2025/1218/P – 15 Shorts Gardens

2025/1218/P – 15 Shorts Gardens – plans and photos

Delegated Report (Members Briefing)		<i>Analysis sheet</i>		<i>Expiry Date:</i>	21/05/2025
		N/A / attached		Consultation Expiry Date:	04/05/2025
<i>Officer</i>			<i>Application Number(s)</i>		
John Nicholls			2025/1218/P		
<i>Application Address</i>			Drawing Numbers		
15 Shorts Gardens London WC2H 9AT			See draft decision notice		
<i>PO 3/4</i>	<i>Area Team Signature</i>	<i>C&UD</i>	<i>Authorised Officer Signature</i>		
<i>Proposal(s)</i>					
Installation of 1x new Air Source Heat Pump (ASHP), replacement of the existing rooflight with a new flat roof incorporating a new access hatch, air intake and extract fan openings at first floor roof level.					
Recommendation(s):		Granted conditional planning permission			
Application Type:		Full Planning Permission

Proposal: Installation of 1x new Air Source Heat Pump (ASHP), replacement of the existing rooflight with a new flat roof incorporating a new access hatch, air intake and extract fan openings at first floor roof level.

Proposed 1st floor roof plan with replacement rooflight and ASHP, extract and vent

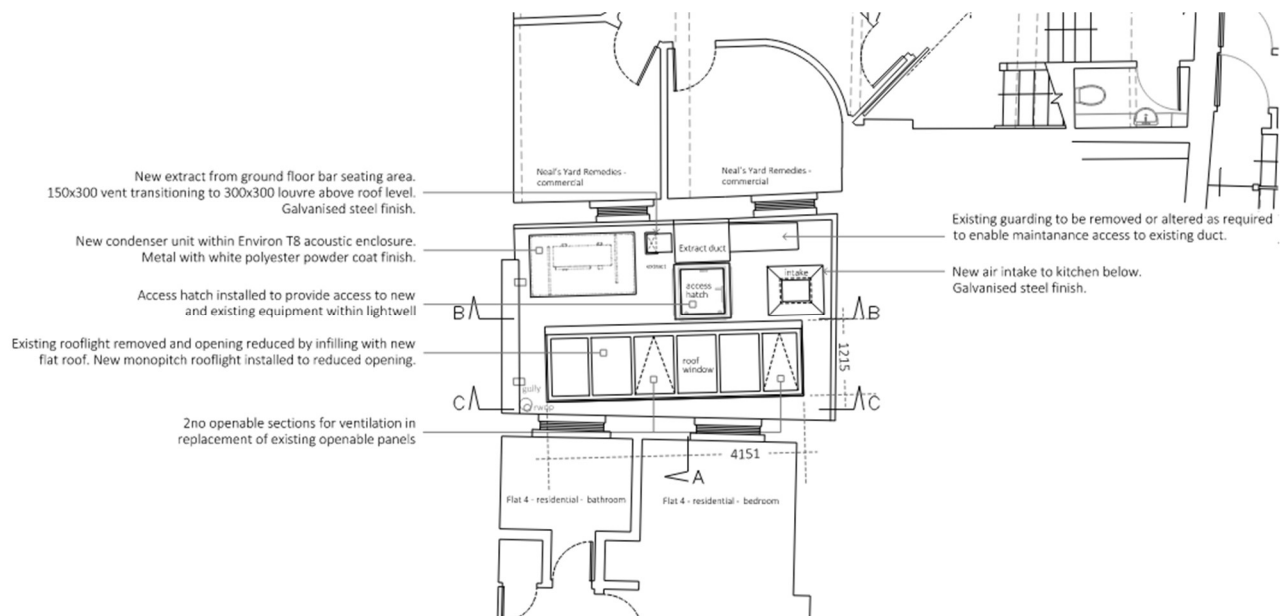
- No provision has been made to measure the sound level after the installation, which would ensure the correct levels are met.
- The new rooflight is higher than the existing ones and will project more sound from the property below due to the removal of the partition wall in the unit below. There should be no need for an openable pane in the rooflight with the ASHP, and this would be uneconomical to run the ASHP with an open window, and therefore this openable pane should be removed from the flat roof.

- Any openable roof lights will allow noise to escape from the restaurant below, up into this confined lightwell space and to the living rooms and bedrooms above. The business occupying the restaurant unit below will not be able to silence things like customer noise. We therefore ask that any roof lights are not openable but fitted as sealed.

- *The openable panes in the proposed new rooflight reflect the openable panes in the existing rooflight and also allow for some cross ventilation through the premises, which is a requirement (should it be available) to ensure that active cooling is not used unless it is required. These will only be open when required and not all the time.*

- *The openable panes in the proposed new rooflight reflect the openable panes in the existing rooflight, and therefore customer noise may have already been an issue, and what is proposed is no worse than the existing situation. The ability to open the rooflights also allows for some cross ventilation through the premises, which is a requirement (should it be available) to ensure that active cooling is not used unless it is required. These will only be open when required and not all the time.*

- 3.4 Objections have been raised related to the replacement rooflight having openable windows fitted as these may allow noise from customers using the commercial unit below to be heard in the lightwell above. The request was that these should be sealed shut. However, the existing rooflight already has openable ventilation panels fitted and therefore it would be unreasonable to restrict these in a revised form of the rooflight. In addition, as part of the assessment for the ASHP, there is a requirement to prevent heat build up by providing openable windows which allow ventilation into and through the commercial unit, and therefore these openable panels also serve this purpose. The rooflight is not proposed to be open at all times, only when required for ventilation, as is the existing situation. The applicants have accepted a condition that these should remain closed between 23:30 and 08:00 daily.

- 7 The openable windows in the replacement rooflight hereby approved shall be kept closed outside of the hours of 08:00-23:30 daily.

Proposed elevation as seen from the residential windows showing replacement rooflight hiding plant behind it and screening it visually and from noise.

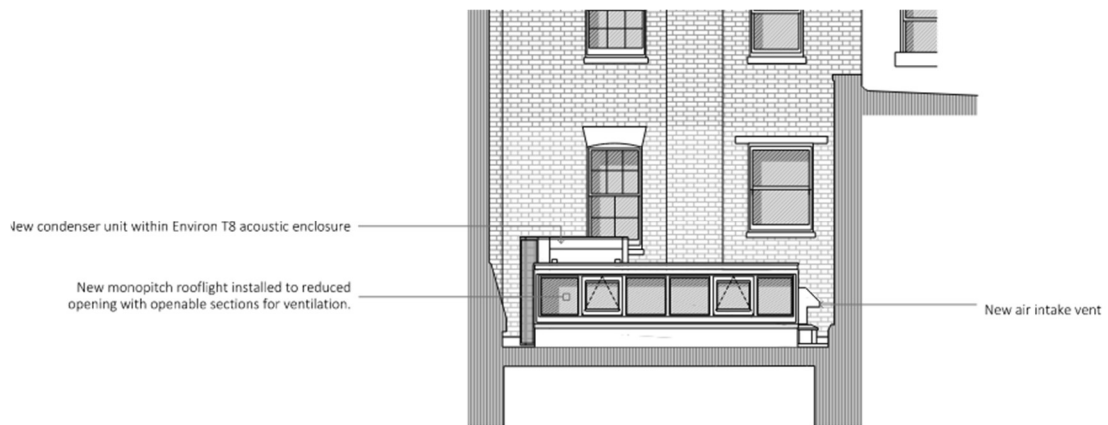
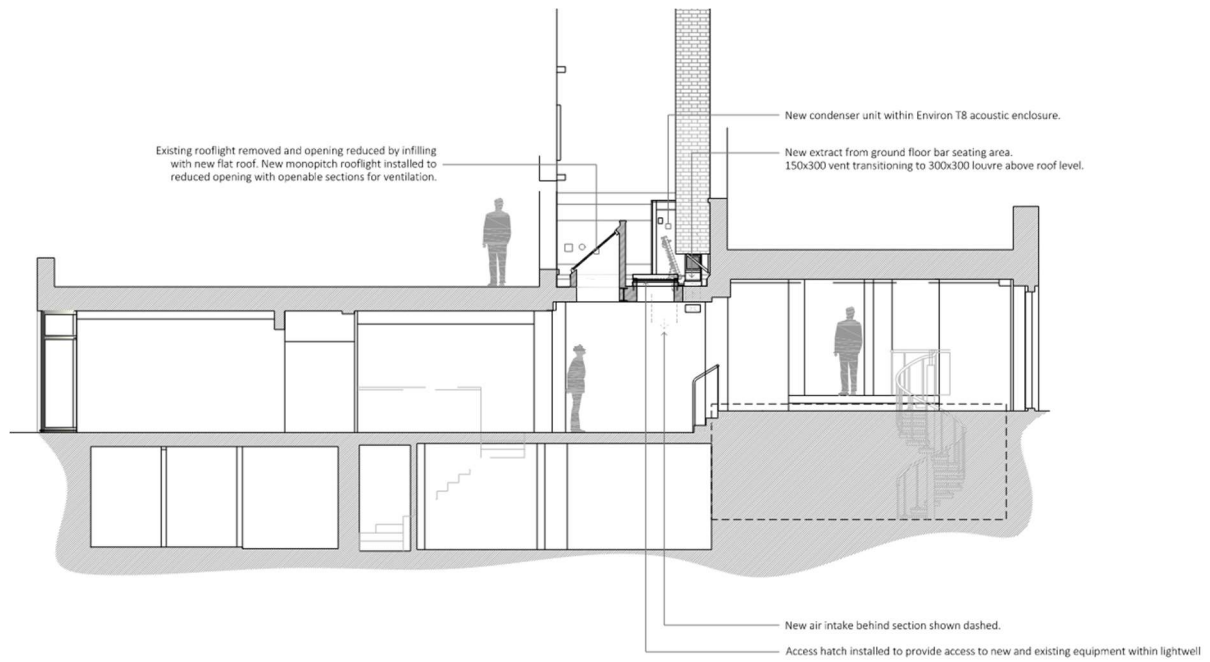
- The proposal raises the level of the observable roof and equipment and will be visible and unsightly when viewed from the flat windows.
- The ASHP could be situated on top of the main roof rather than in the lightwell void.

- Please attach a condition to any consent that requires all equipment to be turned off between the hours of 22:00 and 08:00.
- The proposed location of the large condenser unit is directly outside a residential window. This will harm the amenity of those living there, blocking the view; relocation to the (main) roof would avoid this issue.

- *The change in angle of the rooflight is minor, and there is a slight height change from 1.1m to 1.3m. The increased angle helps screen the new plant from residential units.*

- *The location of the ASHP at main roof level was explored, but was not feasible, due to design, amenity, structural alteration and maintenance reasons. The location of the plant is against the commercial unit windows on the far side of the roof and located behind the proposed replacement rooflight.*

3.10 The outlook from the residential windows within the lightwell are limited and look down onto the existing rooflight at first floor level. The additional plant and ASHP in its acoustic enclosure is not considered to harm outlook any further, as the plant elements will be hidden behind the replacement rooflight and will largely be out of site. This is particularly so from the first floor flat which is closest to the proposal.
